Airworthiness Directives; Eurocopter France Model AS355E, F, F1, F2, and N Helicopters

ACTION: Notice of proposed rulemaking (NPRM).

Eurocopter France: Docket No. 2003-SW-10-AD. Supersedes AD 2002-21-51, Amendment 39-12982, Docket No. 2002-SW-48-AD.

Figure 1

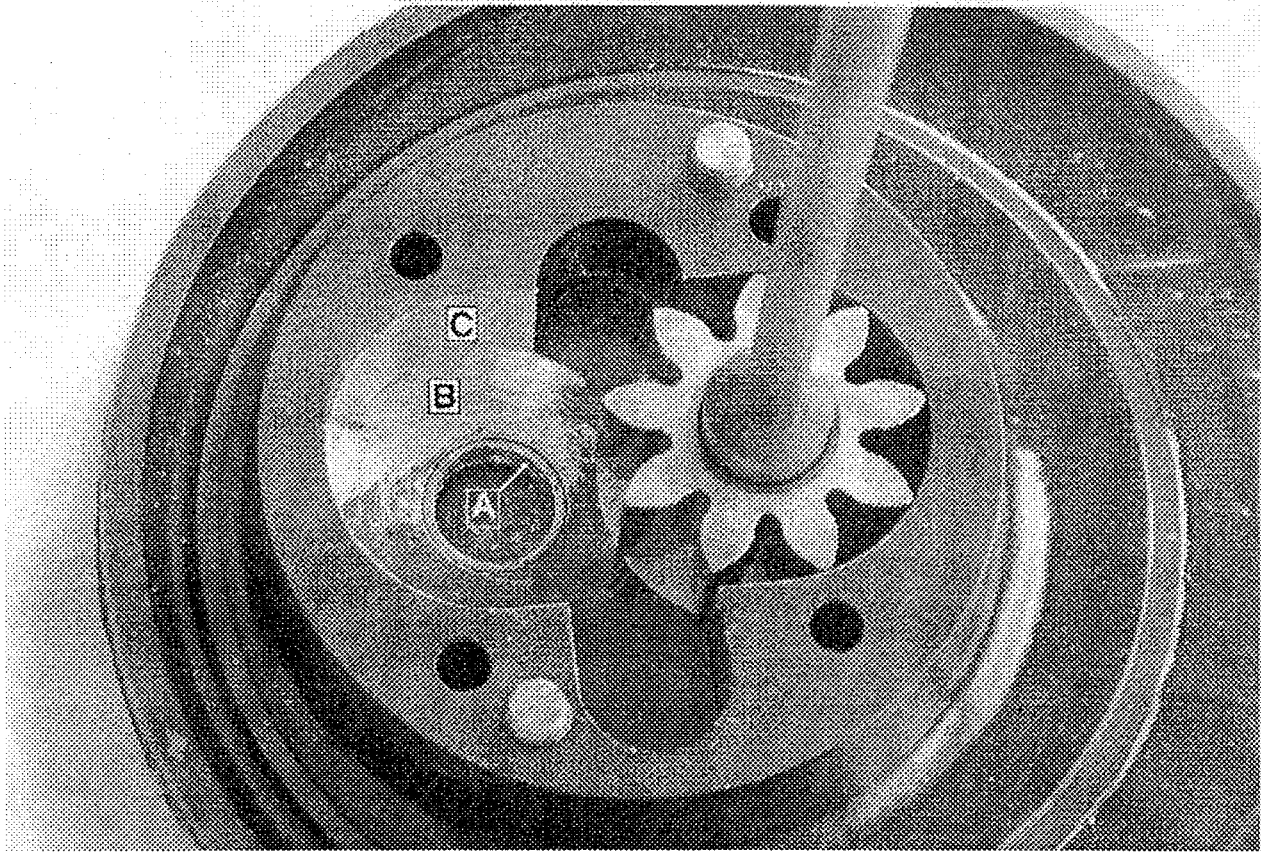
(d) While inspecting the pump, if you find any of the following, replace the MGB and the pump with an airworthy MGB and pump before further flight:

- (1) Crank pin play,
- (2) Out of round bronze bushing (A of Figure 1),
- (3) Offset of the driven gear pinion,
- (4) Metal chips, or
- (5) Wear (C of Figure 1).

Note 2: If wear is present in the B area only as depicted in Figure 1, replacing the MGB and the pump is not required.
